P&Z CASE # SP2022-040 P&Z DATE August 9, 2022 CC DATE N/A Approved/Denied

PROJECT NUMBER: SP2022-040
PROJECT NAME: Site Plan for John King Office Park
SITE ADDRESS/LOCATIONS: 1940 N JOHN KING BLVD

CASE CAPTION: Discuss and consider a request by Jeff Carroll of Carroll Architects, Inc. on behalf of Aaron Davis of SBM Real Estates Services for the approval of a Site Plan for an Office Park on a 2.36-acre tract of land identified as Tract 1-2 of the W. H. Baird Survey, Abstract No. 25, City of Rockwall, Rockwall County, Texas, zoned Planned Development District 10 (PD-10) for Commercial (C) District land uses, situated within the SH-205 By-Pass Overlay (SH-205 BY-OV) District, located on the west side of John King Boulevard south of the intersection of John King Boulevard and SH-276, and take any action necessary.

DEPARTMENT	REVIEWER	DATE OF REVIEW	STATUS OF PROJECT
PLANNING	Henry Lee	07/22/2022	Needs Review

3 WALL SECTION @ DUMPSTER ENCLOSURE
 SCALE: 1/2" = 1'-0"

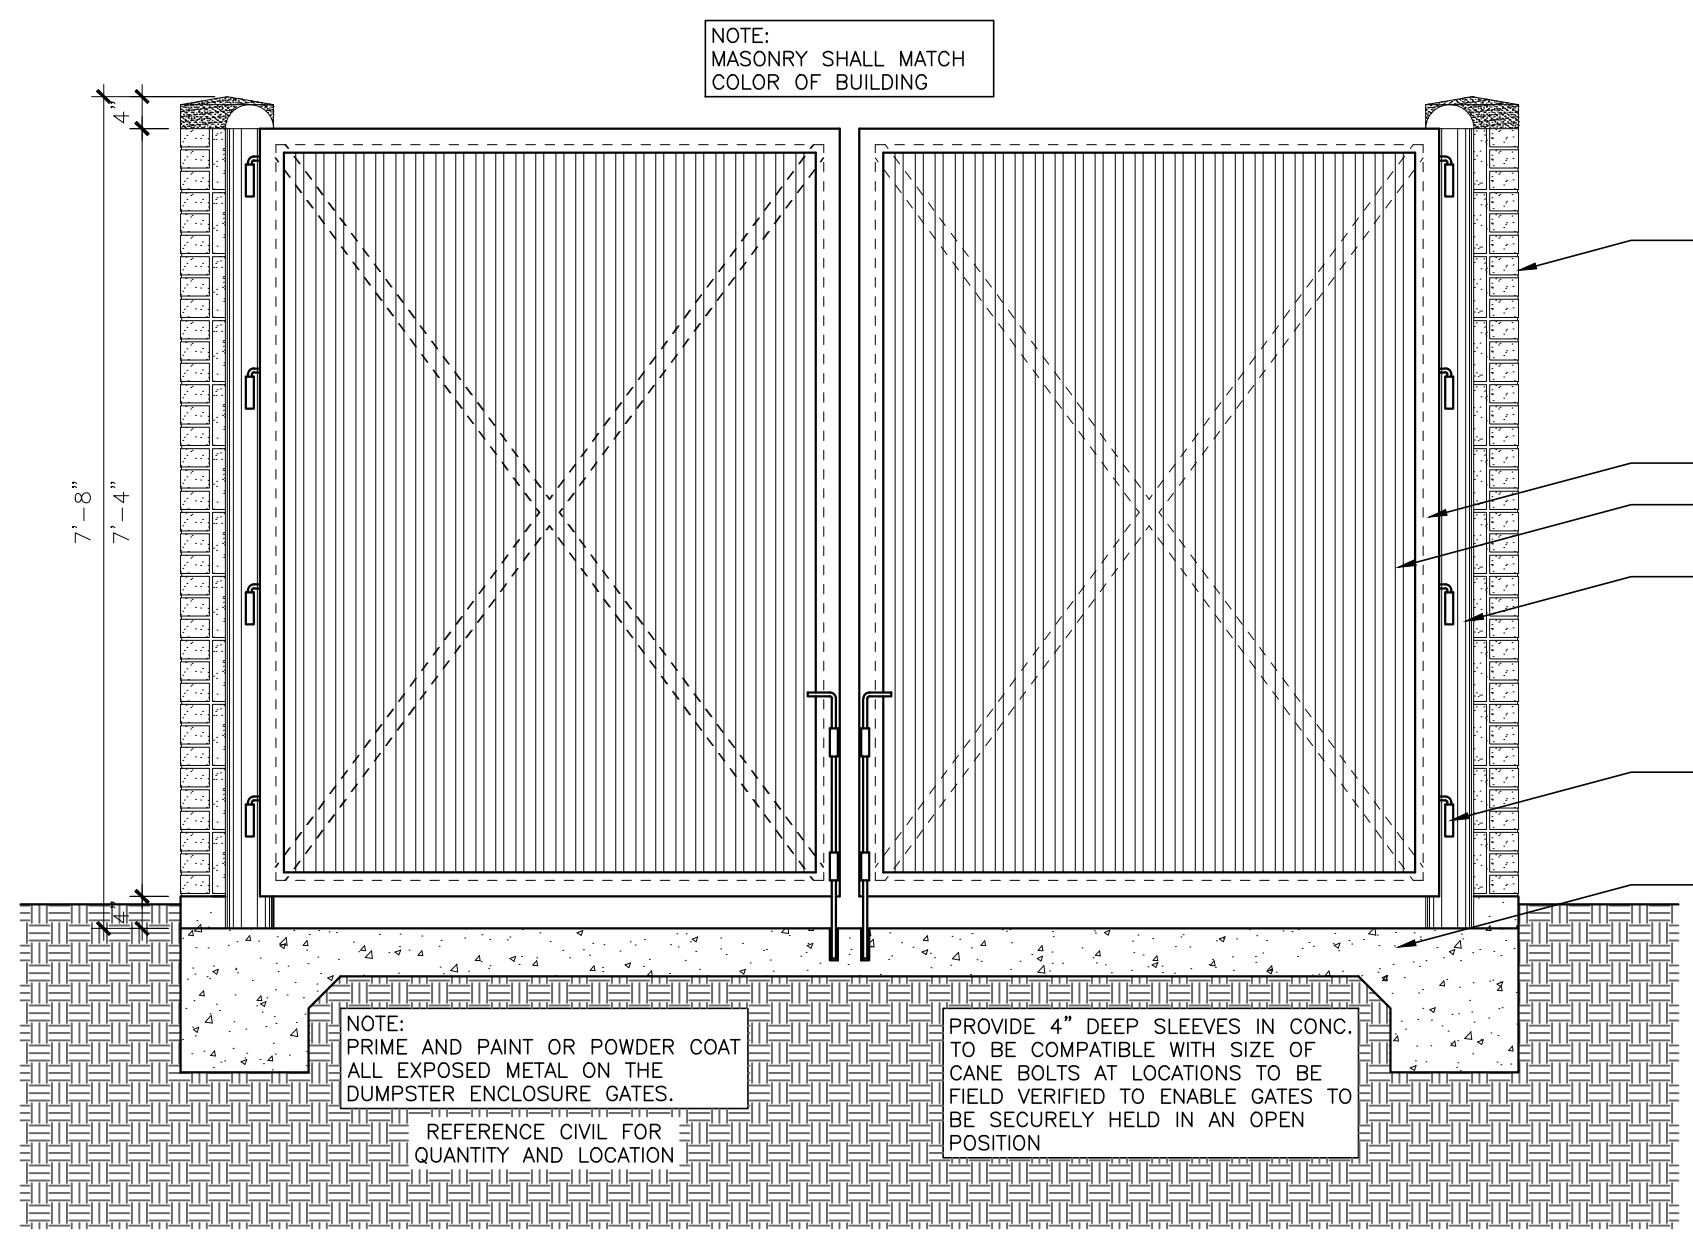
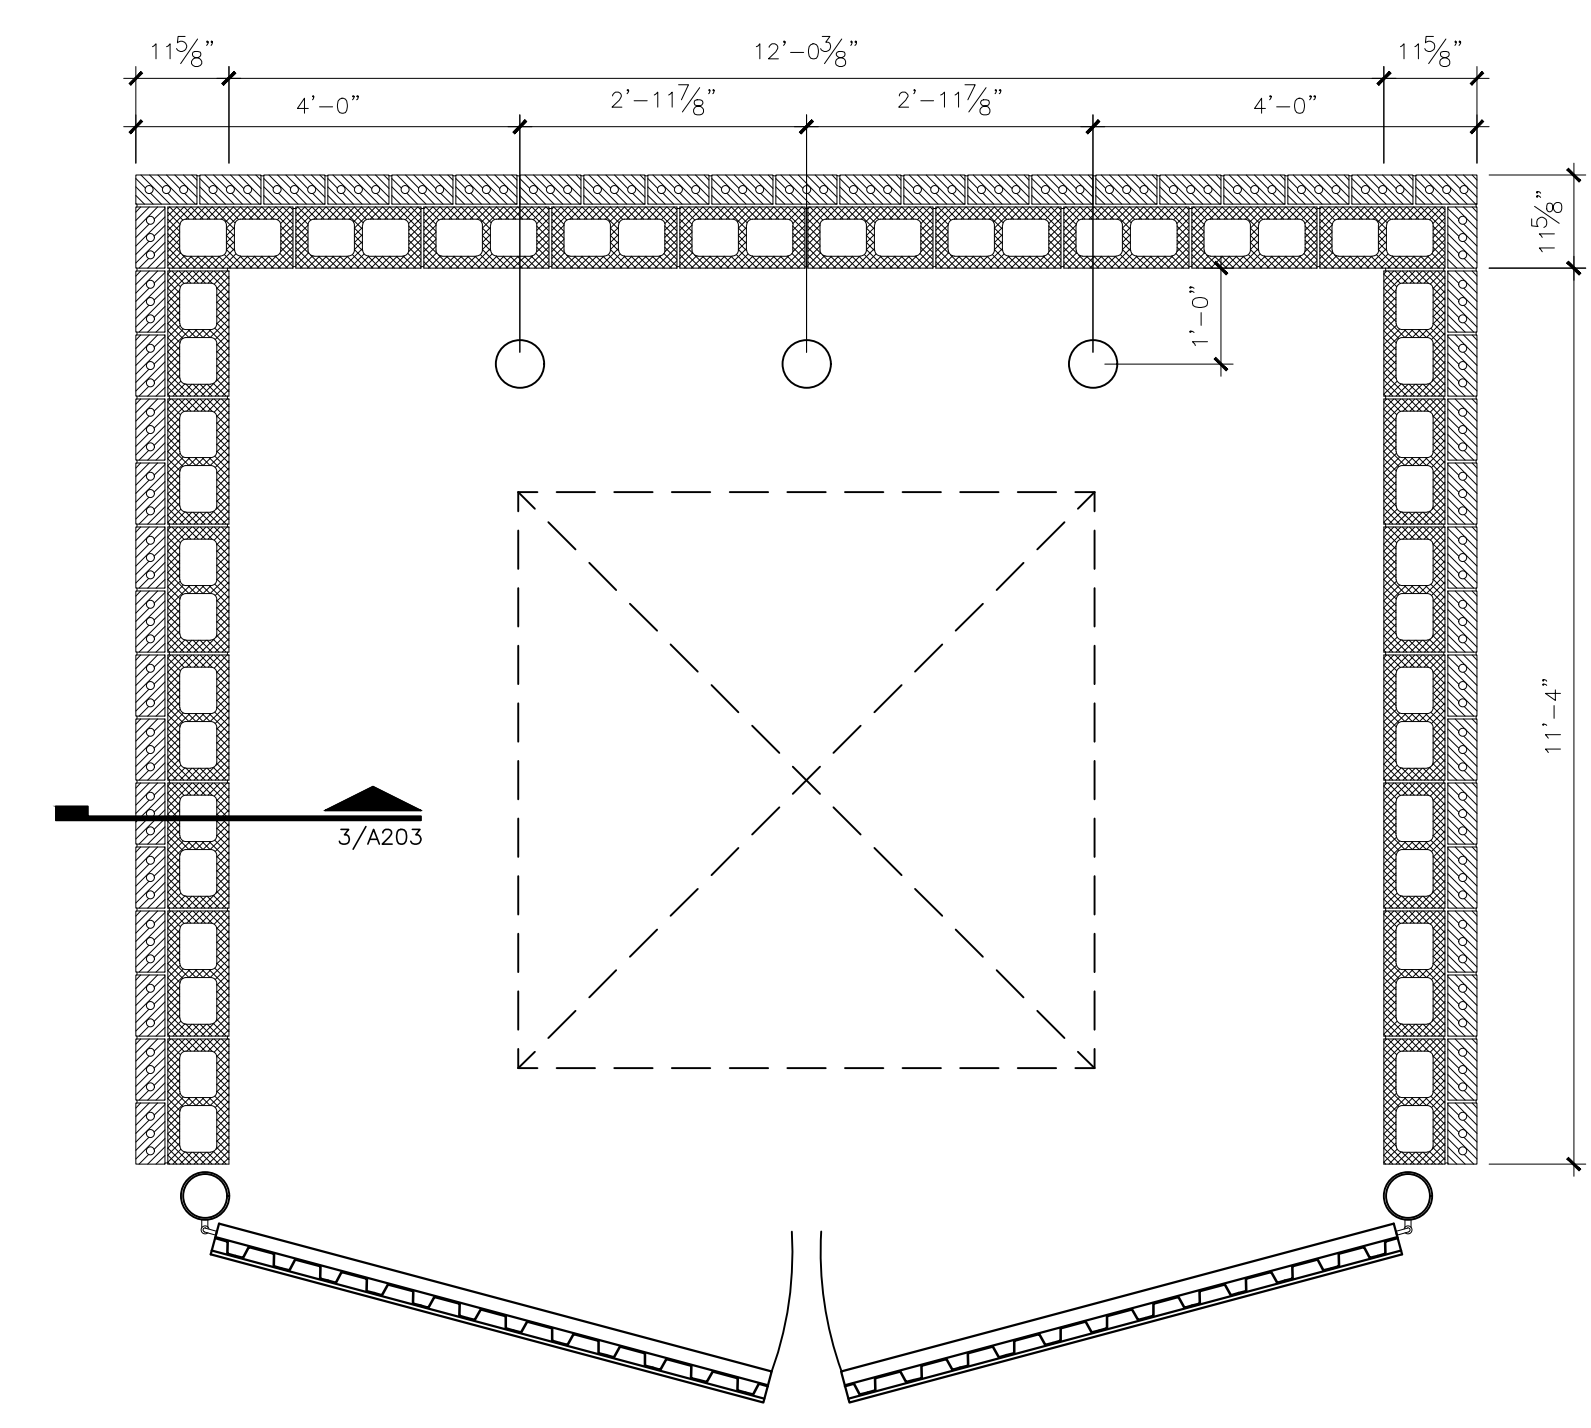
9. Dumpster Screening. The masonry screening wall must be 12-feet by 10-feet, and 8-feet in height because the property is located in an overlay district. The gate must be self-latching and not manual. The dumpster enclosure must be faced in the same material as the primary building. The enclosure must have 5-gallon shrubs planted around it. Please provide a detail. (Subsection 01.05. B, of Article 05)
